Date: [10/16/09]

PCN No.: [120]

PRODUCT CHANGE NOTIFICATION, XPort 04

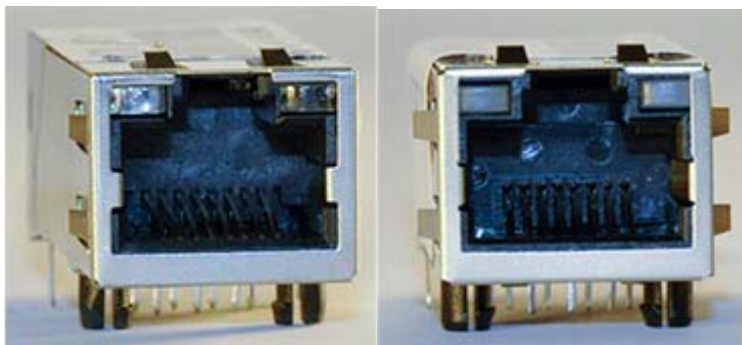
1. The number of spacers at the base of the XPort 04 were increased from 1 to 3 to add more placement stability. The height of the spacers remain the same.

XPort 03

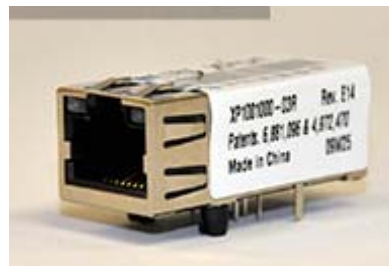
2. The XPort 03 has a solder ball visible on the back of the metal cover while the XPort 04 does not have this solder ball. The XPort 03 does not have tooling marks at the bottom of the unit while the XPort 04 does.
3. The XPort 03 has LEDs at the front while the XPort 04 uses light pipes. The wipers in the XPort 03 touch the top of the combs. The XPort 04 has wider combs which will show a small gap at the front of the comb.
